Access Compliance Report Public Rights-of-Way (Curb Ramps)

Main Street: GROVEMONT_ST Cross Street: ETHELBEE_WAY Location: NW

ADA ID: RPAT210930085849 Ramp Type: Type 1 - Perpendicular Diagonal Initial Pass/Fail: Fail Overall Compliance: No Severity Score: 35

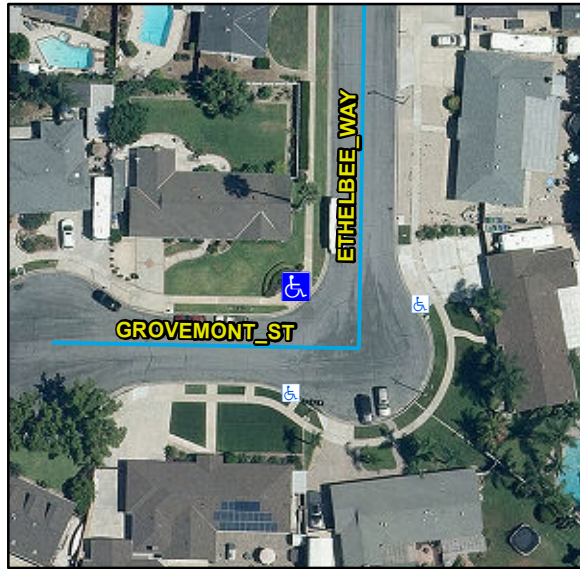
R304.5.1, R304.2.2, R302.7, STD 1115

Compliance	Description	Data	Compliance	Description	Data
N/A	Ramp Length (in)	115	N/A	Flare Type LT	
No	Ramp Width (in)	46			N/A
No	Ramp Run Slope (%)	10.4	N/A	Flare Slope LT (%)	N/A
Yes	Ramp Cross Slope (%)	0.9	N/A	Flare Traversable LT	N/A
N/A	Landing Present	N/A	N/A	Flare Type RT	
N/A	Landing Length (in)	N/A			N/A
N/A	Landing Width (in)	N/A	N/A	Flare Slope RT (%)	N/A
N/A	Landing Run Slope (%)	N/A	N/A	Flare Traversable RT	N/A
N/A	Landing Cross Slope (%)	N/A	N/A	DWS Provided	N/A
N/A	Landing Movement Obstructed?	N/A	N/A	DWS Contrast	N/A
	Landing Movement Type	N/A	N/A	DWS Length (in)	N/A
N/A	Landing Shared	N/A	N/A	DWS Full Width	N/A
N/A	Clear Space	Yes	N/A	DWS Offset Left (in)	N/A
N/A	Clear Space To Crosswalk (in)	N/A	N/A	DWS Offset Right (in)	N/A
N/A	Marked Crosswalk 1	No	N/A	Marked Crosswalk 2	No
	Crossing 1 Direction	S		Crossing 2 Direction	E
	Marked Crosswalk 1 Width (in)	N/A		Marked Crosswalk 2 Width (in)	N/A

Remove & Replace Curb Ramp With Two New Directional Ramps or Equivalent.
